## 110661 - 00

**Change Notification #:** 110661 - 00  
**Change Title:** Intel® Desktop Board DP67BA, Boxed and Bulk  
PCN 110661-00, Product Design  
Hardware Support Added for Future Processors  
**Date of Publication:** May 27, 2011

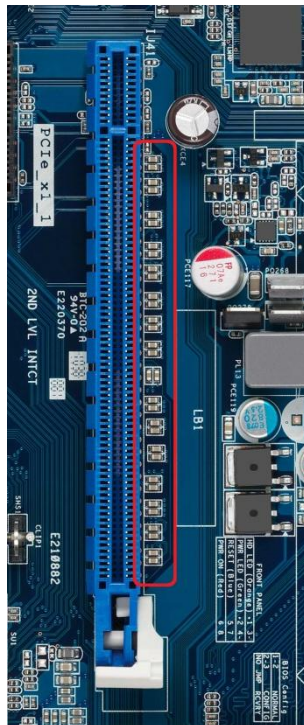
Change the PCIe x16 slot AC decoupling capacitor values from 100nF to 220nF. The capacitor location designators are from XC1 to XC32. You may also refer to the location in the picture below.
